IEEE P802.15 Wireless Personal Area Networks

Project	IEEE P802.15 Working Group for Wireless Personal Area Networks (WPANs)	
Title	D00 running comment resolution	
Date Submitted	[14 March, 2005]	
Source	[James P. K. Gilb] [Appairtent Technologies] [16990 Via Tazon, #125, San Diego, CA 92127]	Voice: [858-485-6401] Fax: [858-485-6406] E-mail: [last name at ieee dot org]
Re:	[]	
Abstract	[This document is a record of comment resolutions for draft D00 of 802.15.3b.]	
Purpose	[To provide a record of the comment resolutions for draft D00 of 802.15.3b.]	
Notice	This document has been prepared to assist the IEEE P802.15. It is offered as a basis for discussion and is not binding on the contributing individual(s) or organization(s). The material in this document is subject to change in form and content after further study. The contributor(s) reserve(s) the right to add, amend or withdraw material contained herein.	
Release	The contributor acknowledges and accepts that this contribution becomes the property of IEEE and may be made publicly available by P802.15.

1. Comment resolution in Atlanta

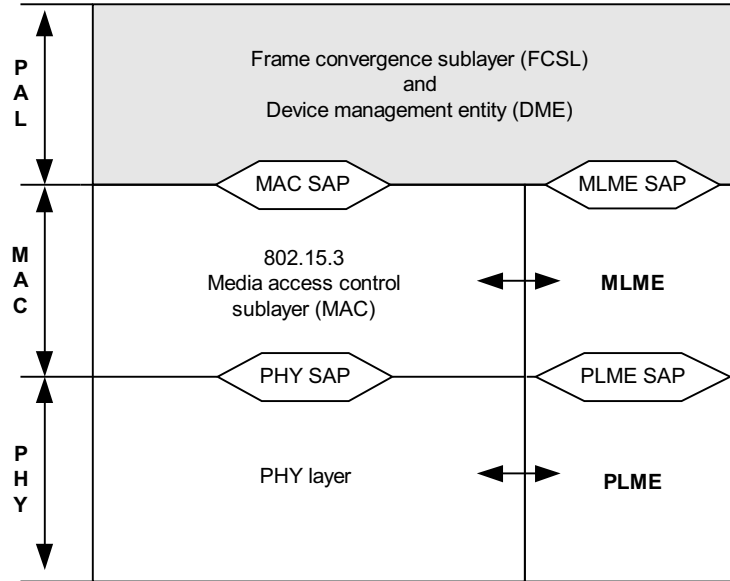
CID 154: ACCEPT IN PRINCIPLE. Replace the current model with the picture in 15-05-0151-04.

CID 29: ACCEPT IN PRINCIPLE. Replace the current model with the picture in 15-05-0151-04. Also, editorial text will be added to explain the changes and the reasons for them changes.

CID 330: ACCEPT IN PRINCIPLE. Replace the current model with the picture in 15-05-0151-04.
